Vermont Agency of Transportation
RECEIVED
Randolph BRO Submittal 1 - Elastomeric Bearing Pad - 20150112.pdf

STATE OF VERMONT
AGENCY OF TRANSPORTATION
BRIDGE NO.35
TOWN HIGHWAY 65 (PALMER ROAD)
CLASS 3 LOCAL ROAD
ITEM NO. 531.17
TOWN OF RANDOLPH

PROJ. NO.: BRO 1444(57)

DYNAMIC RUBBER.:
LAMINATED BEARING PADS

DETAIL 1

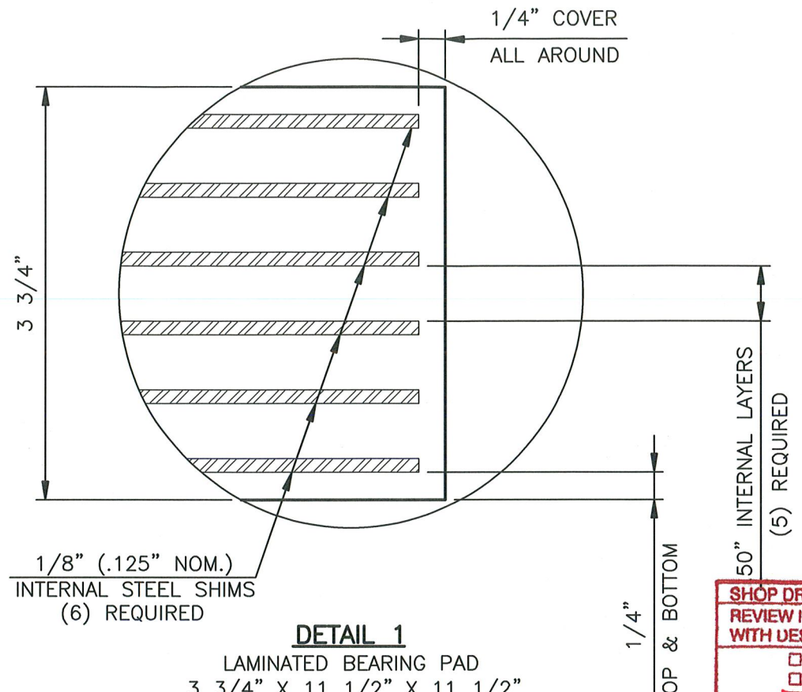
LAMINATED BEARING PAD
3 3/4" X 11 1/2" X 11 1/2"
60 DUROMETER GRADE 4 NATURAL RUBBER
WITH A SHEAR MODULUS OF 130 PSI TO 200 PSI ~~+/- 15%~~
(8) REQUIRED FOR STRUCTURE

LAMINATED BEARING PAD
3 3/4" X 11 1/2" X 11 1/2"
60 DUROMETER GRADE 4 NATURAL RUBBER
WITH A SHEAR MODULUS OF 130 PSI TO 200 PSI ~~+/- 15%~~
(2) REQUIRED FOR TESTING

PLEASE PROVIDE SHOPS FOR THE SHIM PLATES REFERENCED IN NOTE 6 ON SHEET 23.
